ROCKFORD BOARD OF EDUCATION
INVITATION FOR BID ON SUPPLIES, MATERIALS, EQUIPMENT OR SERVICES
FOR SCHOOL DISTRICT NO. 205
ROCKFORD, ILLINOIS

RFQ No. **16-22 Riverdahl Elementary School Additions**

DATE: **Thursday, January 7, 2016**

RE: **ADDENDUM NO. 1**

1 LEVEL 01 FLOOR PLAN - AREA C
1/8" = 1'-0"

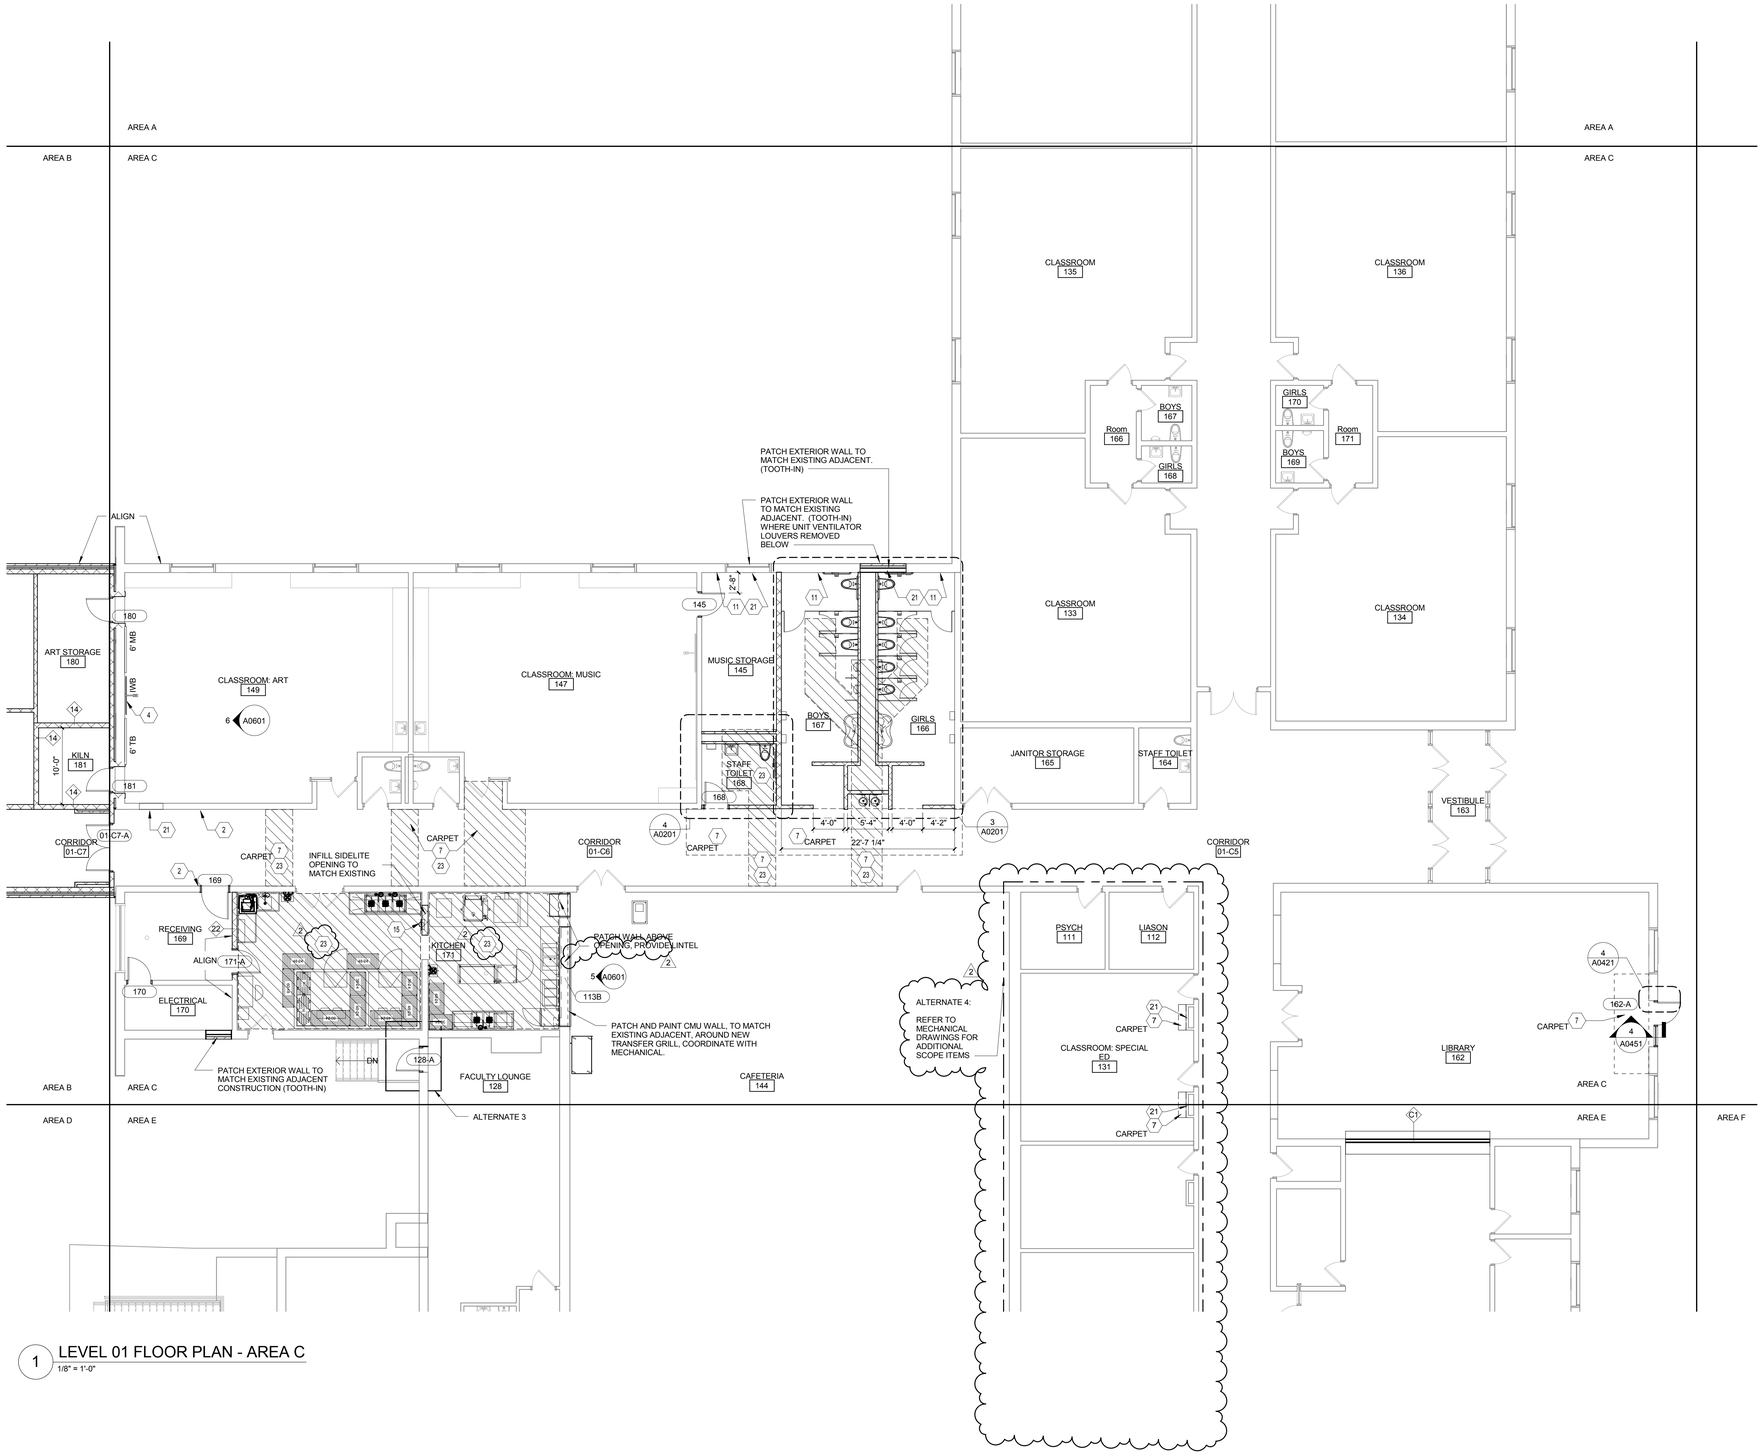
28. A0101.C – LEVEL 01 FLOOR PLAN – AREA C

A. Replace keynote 24 with keynote 23 in both areas of Kitchen 171.

B. Correct spelling of word "PROVIDE" and add arrow above kitchen serving line overhead door.

C. Added Alternate 4 scope

1 LEVEL 01 FLOOR PLAN - AREA D
1/8" = 1'-0"

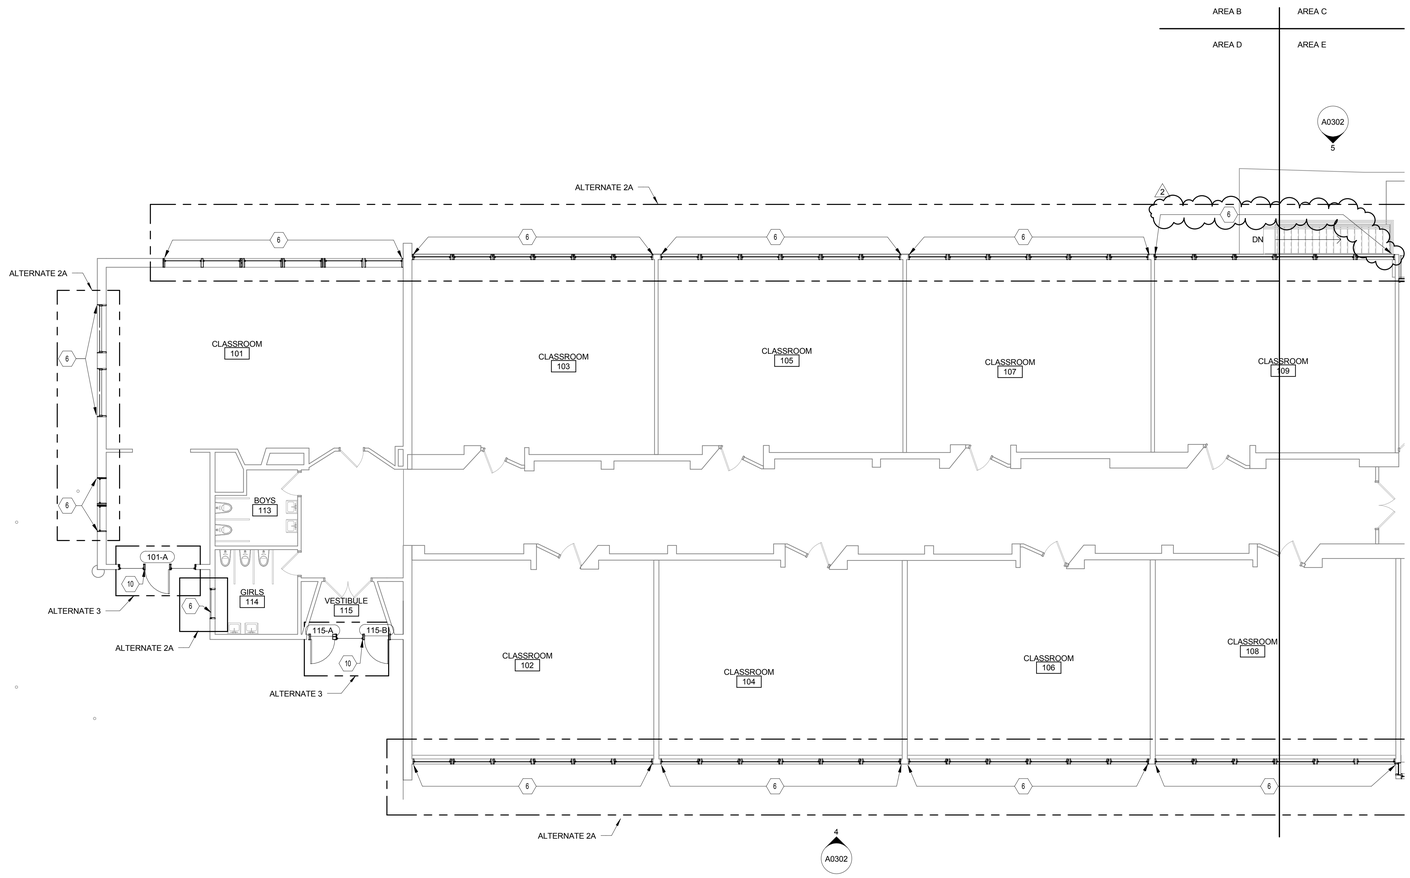
29. A0101.D – LEVEL 01 FLOOR PLAN – AREA D

A. Added arrow on to keynote 6 to include all windows replacement for classroom 109.

1 LEVEL 01 FLOOR PLAN - AREA E
1/8" = 1'-0"

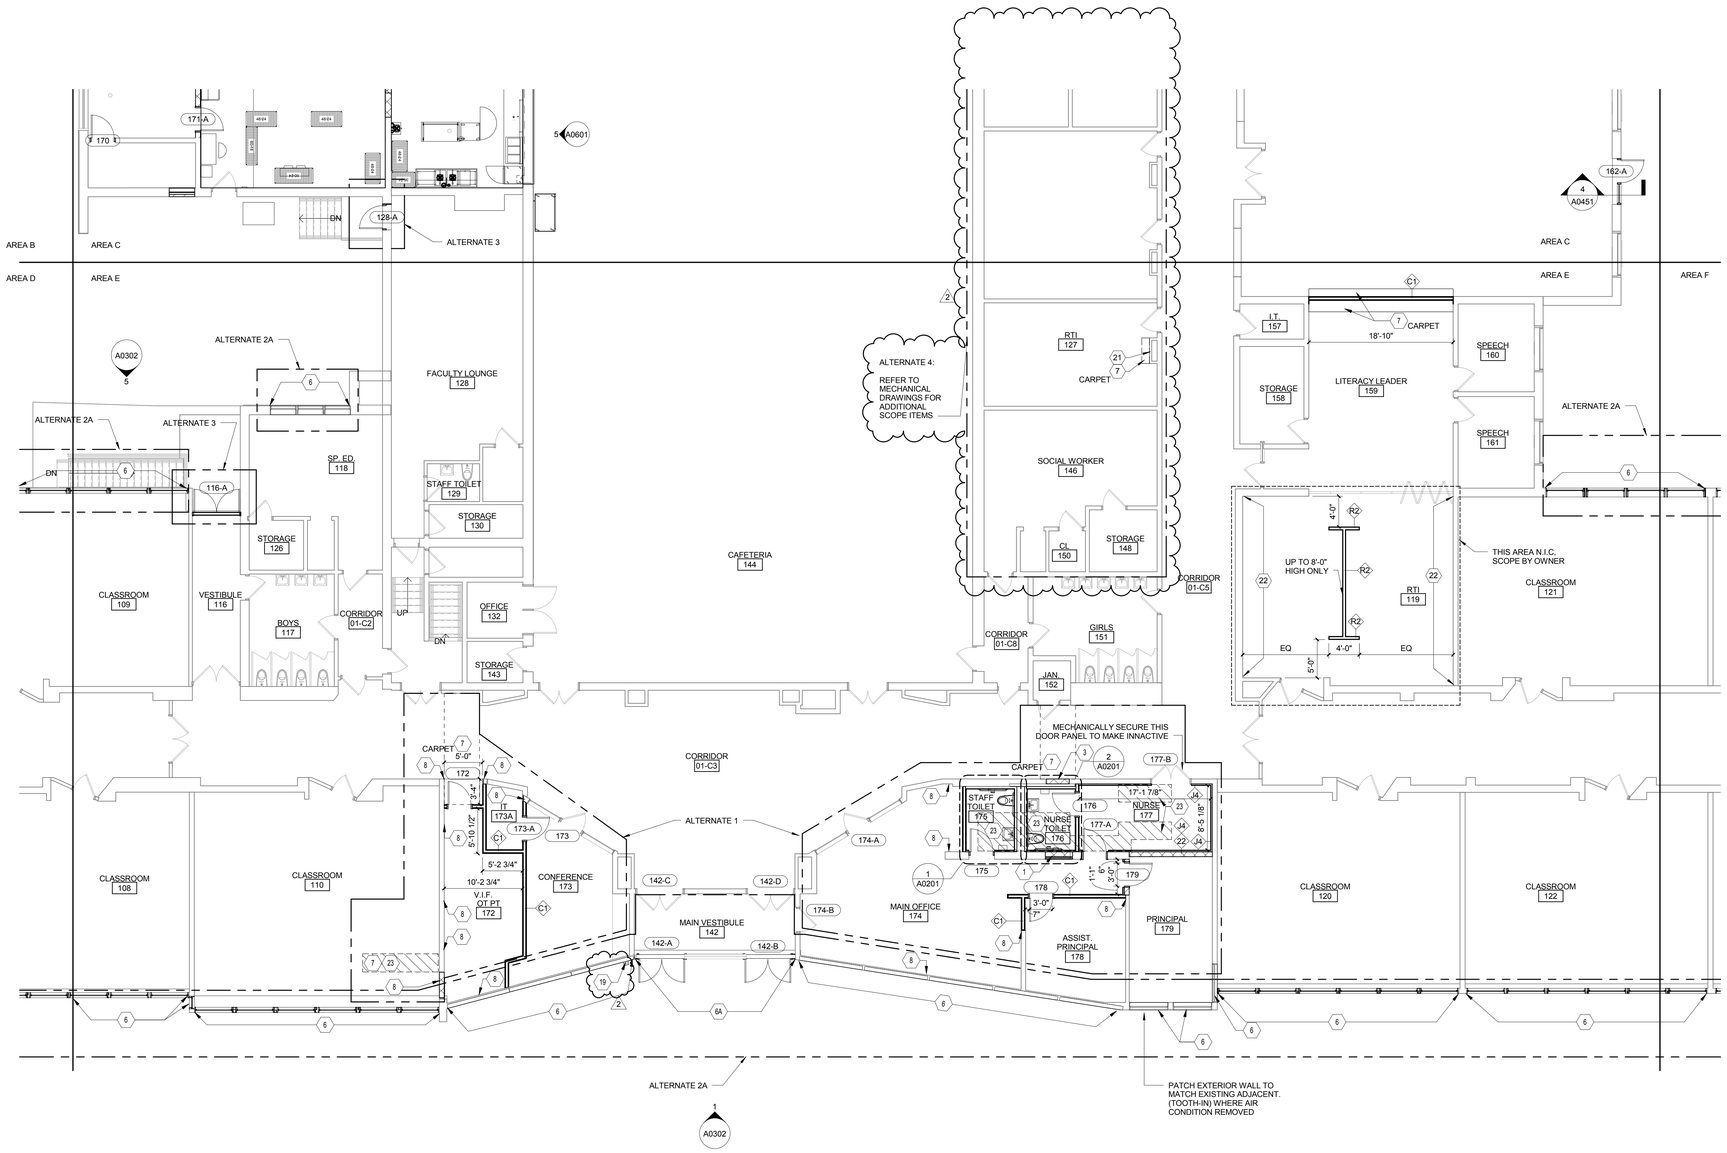
30. A0101.E – LEVEL 01 FLOOR PLAN – AREA E

A. Added keynote 19 and symbol for knox box

B. Added Alternate 4 scope

1 ROOF PLAN - AREA C
1/8" = 1'-0"

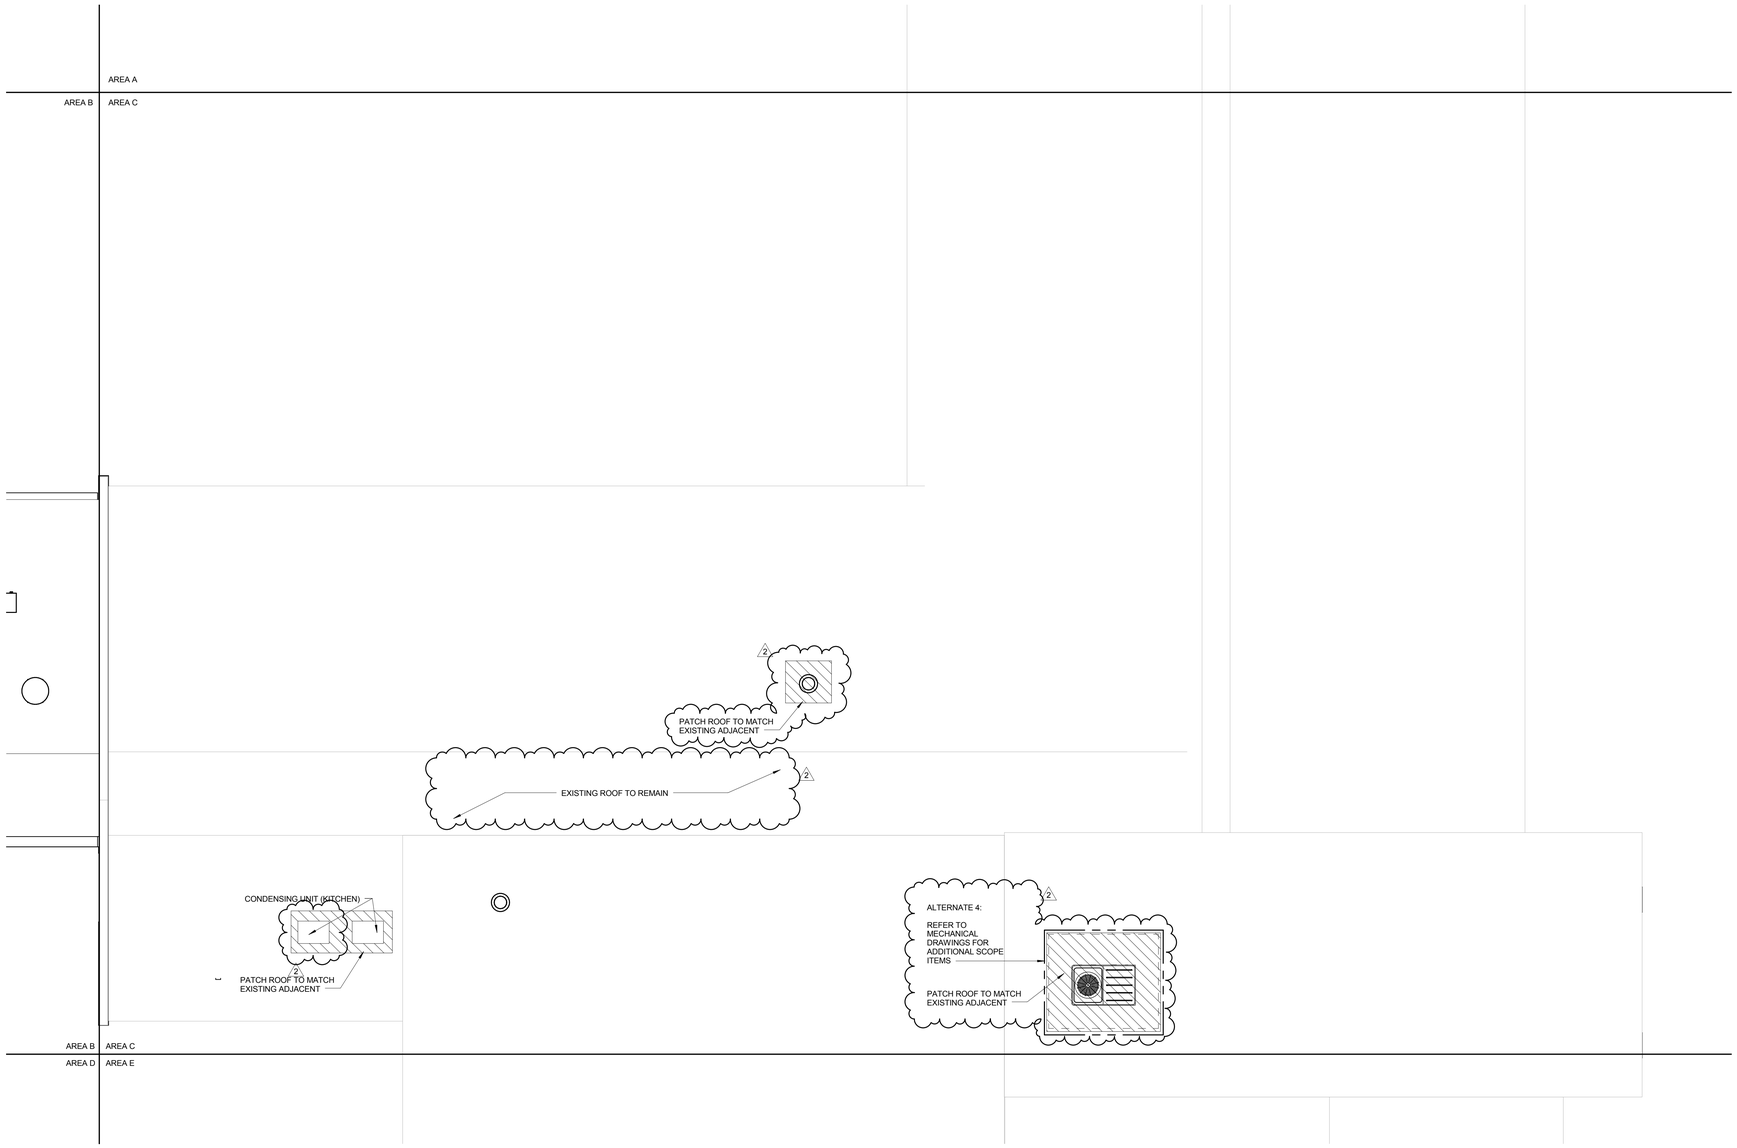
31. A0103.C – ROOF PLAN – AREA C

A. Cleaned up background. Added note "EXISTING ROOF TO REMAIN"

B. Added location for second condenser for kitchen equipment and added roof patch areas.

C. Added alternate outlines

2 NORTH ELEVATION
1/8" = 1'-0"

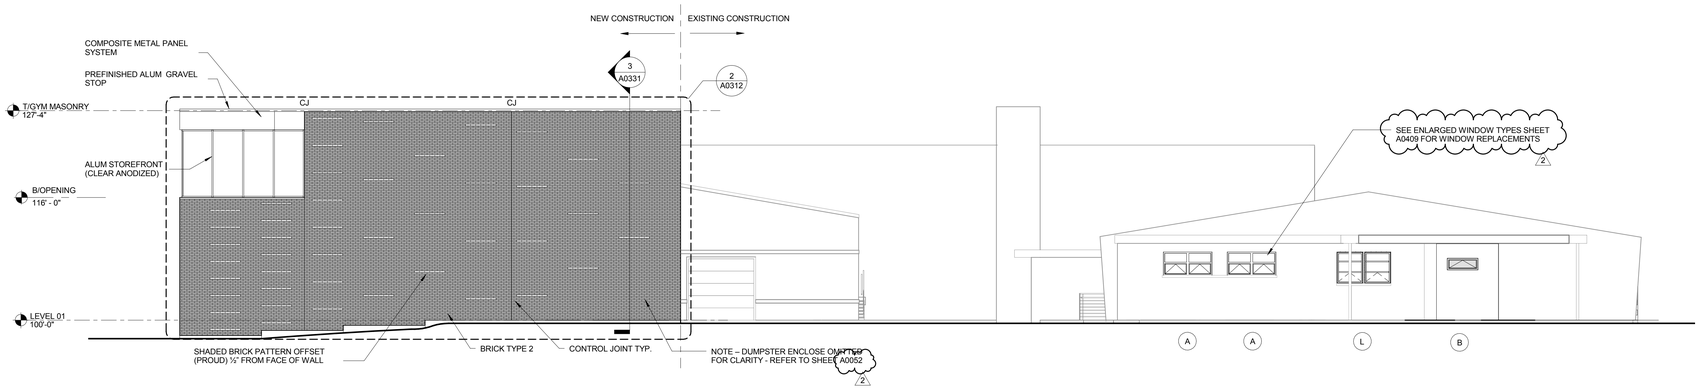
B. View 2, North Elevation, Change reference in note regarding dumpster enclosure from "A0852" to "A0052"

C. View 2, North Elevation, update reference note "SEE WINDOW REPLACEMENT SHEET

A0311" to say: "SEE ENLARGED WINDOW TYPES SHEET A0409 FOR WINDOW REPLACEMENTS"

1 LEVEL 01 POWER AND SYSTEMS PLAN - AREA E
1/8" = 1'-0"

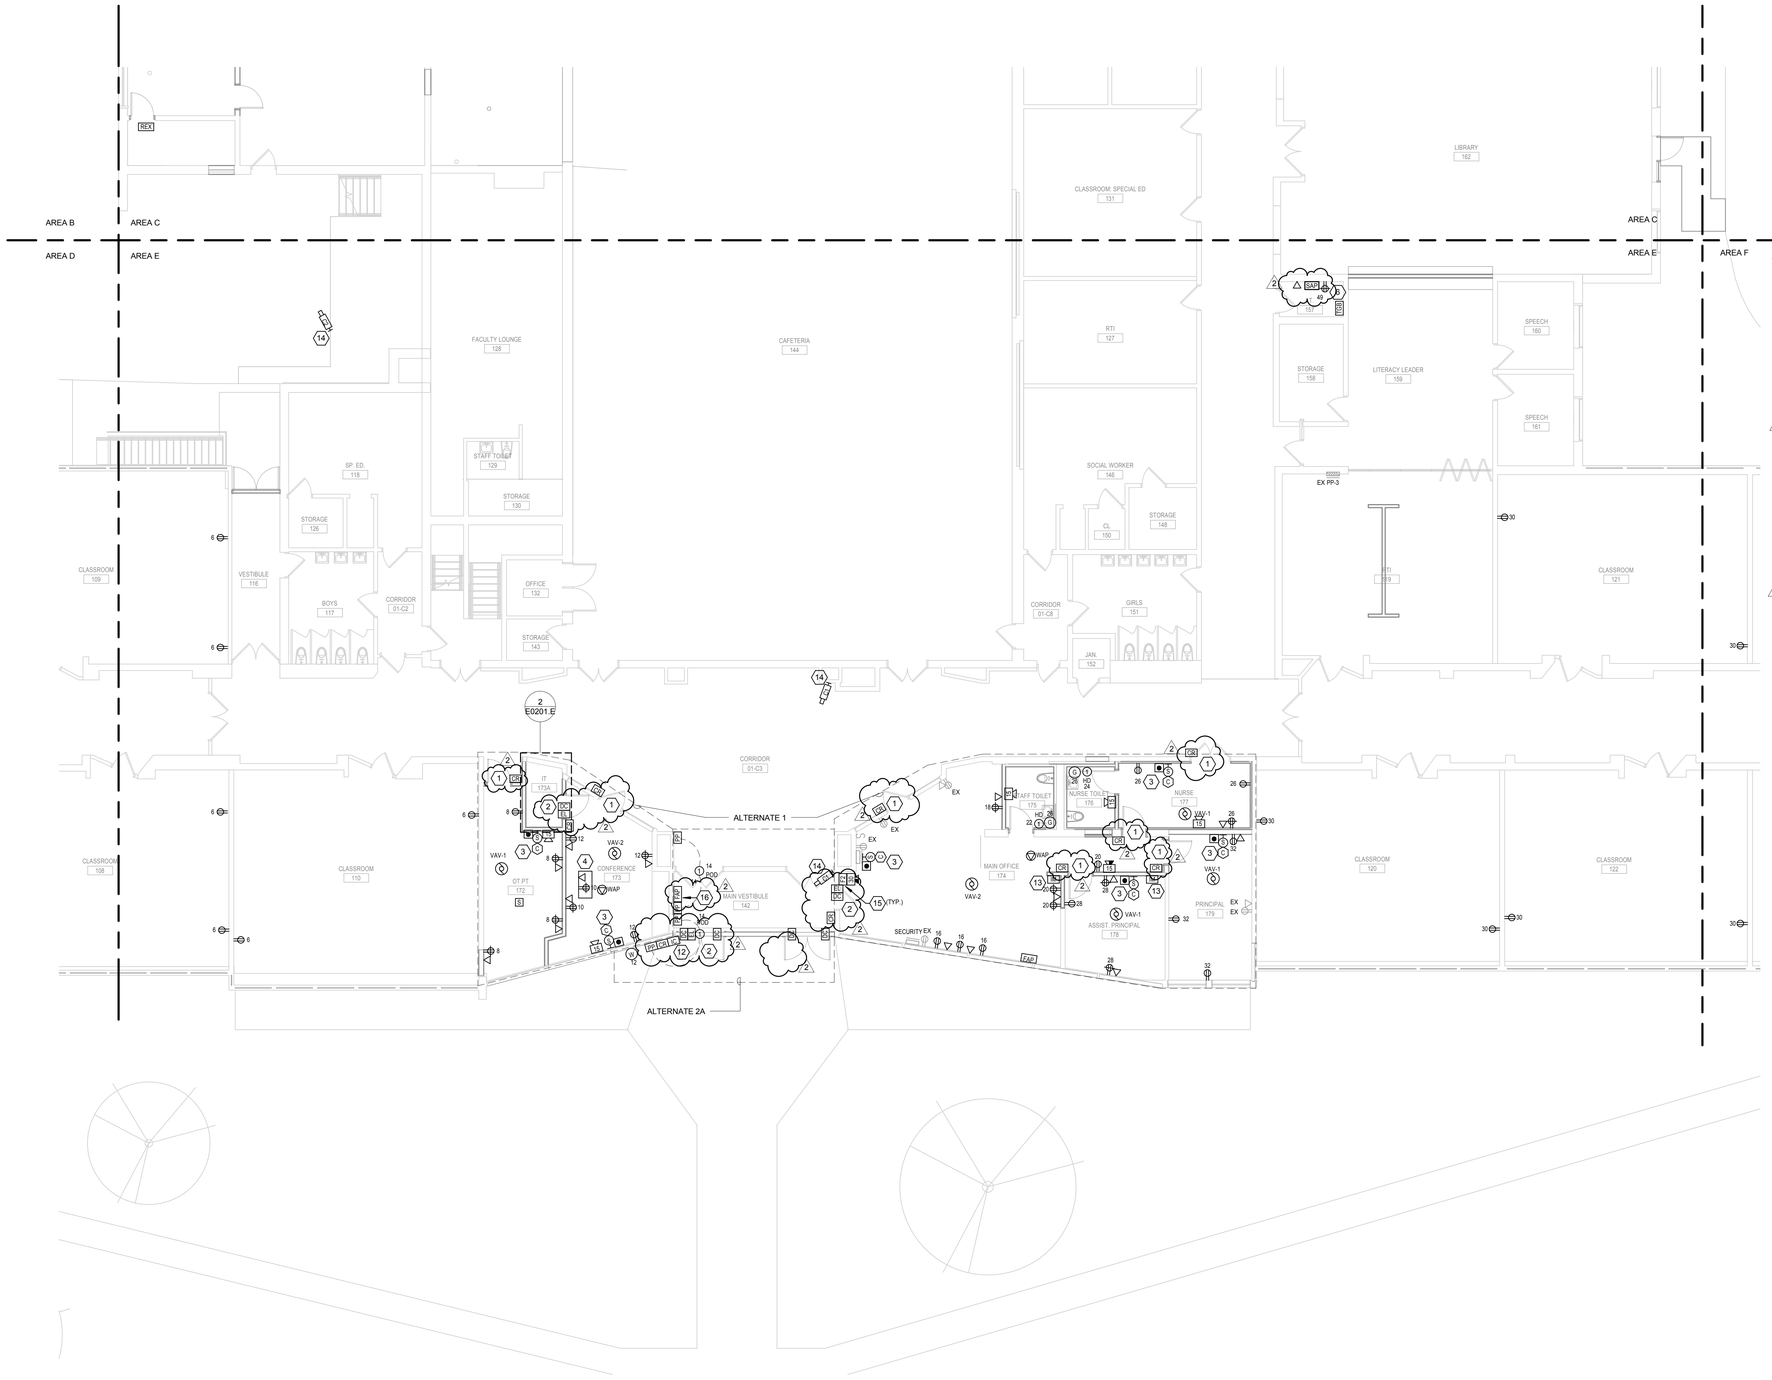
55. E0201.E – LEVEL 01 POWER AND SYSTEMS PLAN – AREA E

C. Added keyed note 16, “NEW FIRE ANNUNCIATOR PANEL TO BE INCLUDED IN BASE BID.”
